July 14, 1999

This letter is to request a review of several changes planed to the Metorex SIPS probe which is currently covered by Registry NR-0701-D-104-B. These modifications are in the latter stages of design and evaluation but have not yet been formalized. These changes will be implemented in the fall of 1999 and will occur in all probes. Thus, these modified probes will be identified by a serial number greater than a certain number that will be determined at a later date.

Modifications to SIPS Probe NR-0701-D-104-B

Attachment 1A

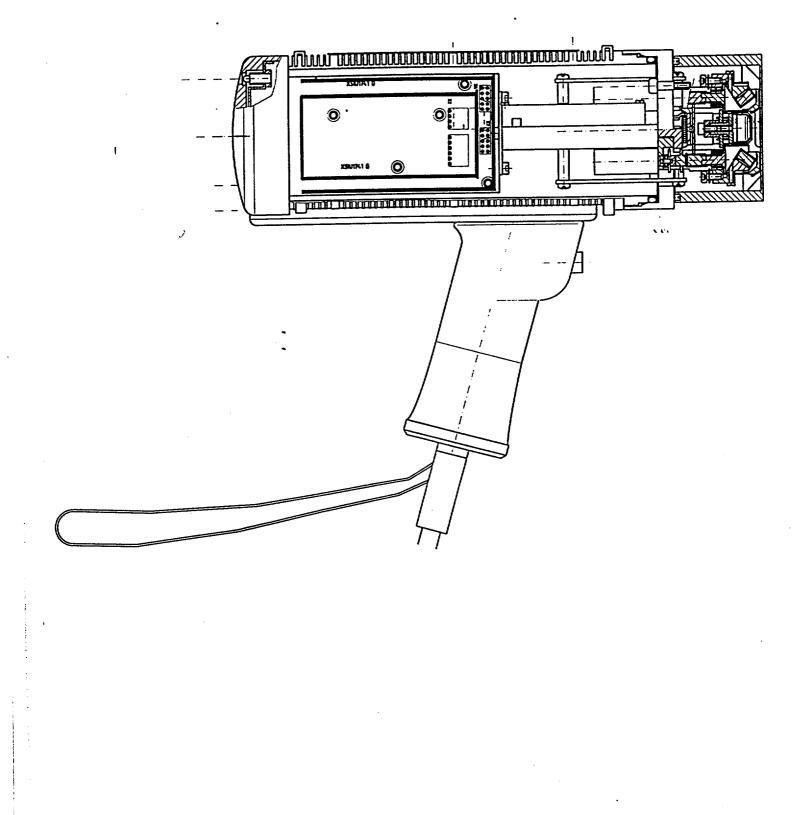
Attachment 1A (p3) is a drawing of the redesigned probe. Two external modifications have been made to the probe. First, three of the groves in the body of the probe have been eliminated. This provides a more secure mounting for the screws that hold the radiation warning label. The second change is that a new handle has been designed which better fits the grip and includes a safety strap to minimize the chance of dropping the probe. In addition, the probe cable now enters the probe through a connector rather than being hard wired to the probe.

Attachment 2A

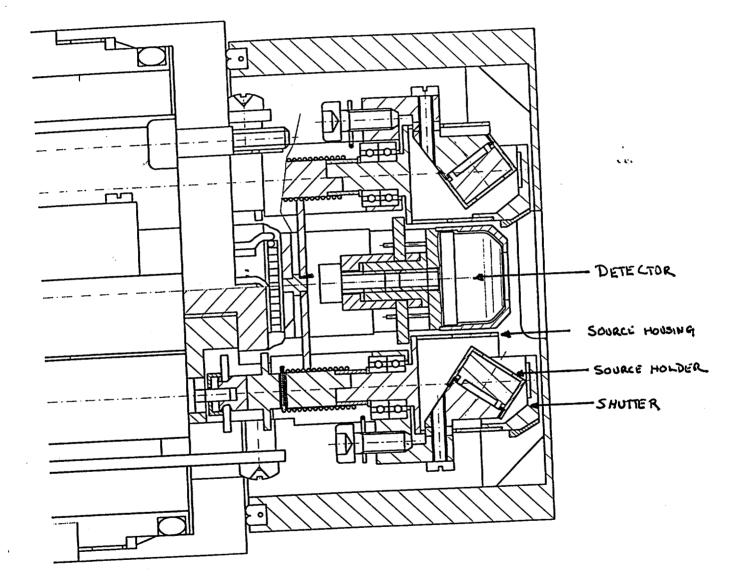
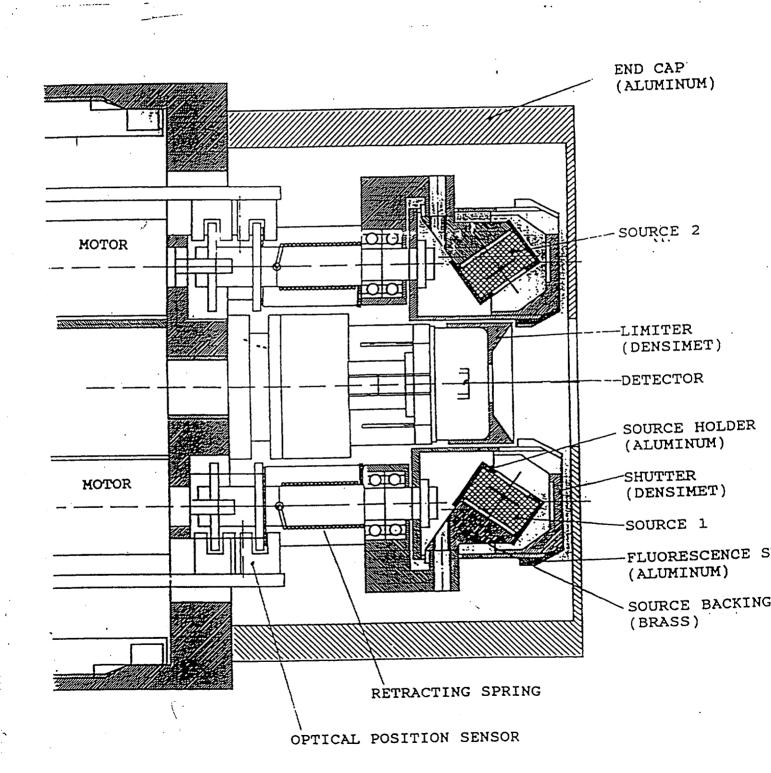
Attachment 2A (p4) shows the modification of the detector geometry. In this view, the lower shutter is opened and the upper shutter is closed. When compared to Attachment 2 (p5) from the registry, the change in the position of the detector can be seen. The detector is much closer to the front of the probe. In order to shield the detector from the source, the source housing has been modified slightly (p6). Thus, the shutter opening is slightly smaller than in the original probe. Otherwise, no changes have been made to the source holder and/or the shutter mechanism.

Attachment 3A

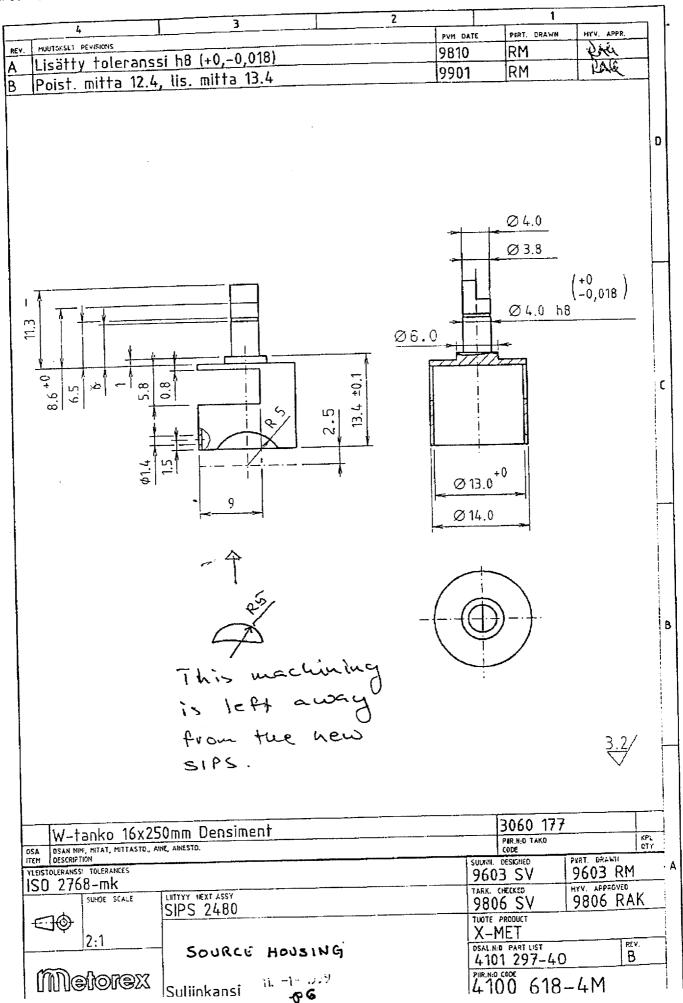
Attachment 3A (p7) illustrates the new heat shield and end cover. The heat shield (Attachment 4; p8) is an option for the unit to allow the probe to be used at elevated temperatures. The shield and associated mounting slightly separate the probe from the sample and provide some insulation. The installation of the heat shield slightly extends the length of the probe snout. Thus, with and without the shield, the probe snout will be of different lengths. This has lead to the development of a new end cover. In this version, the cover is fixed onto the probe snout with two spring loaded balls in the side of the cover. These balls fit into the small conical recesses in the probe snout. The cover is slightly longer than the old version and shielding mechanism is floating on four (4) springs. Two (2) bars on the side of the cover limit the outward movement. The same cover is used with or without the heat shield. The shielding mechanism is sandwich composed of a lead sheet between a steel and aluminum sheet. A copper reference sample is attached to the front of the sandwich. The steel plate adds to the shielding provided by the cover when compared with the previous cover.

FIGURE 10. LOCATION OF DOSE RATE MEASUREMENT POINTS

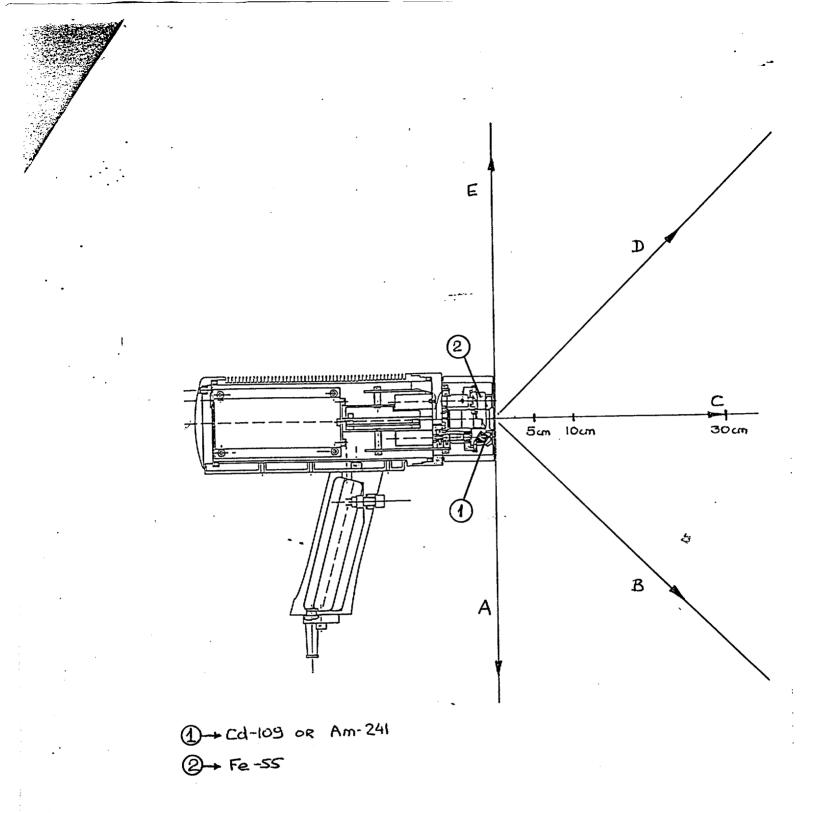
In order to determine the effect of these changes on the radiation profile, measurements were made using the same Cd-109 source in both the current designed probe and the revised probe. Cd-109 was chosen as it has the highest radiation profile in the testing of the original probe. The measurements were made using a Giger counter to monitor the primary beam. A scintillation detector was used to measure the weak radiation in other directions. The following comparative table shows the radiation along the axis illustrated in figure 10 (p9):

These profiles indicate that there is essentially no difference in the radiation profiles of the two designs.
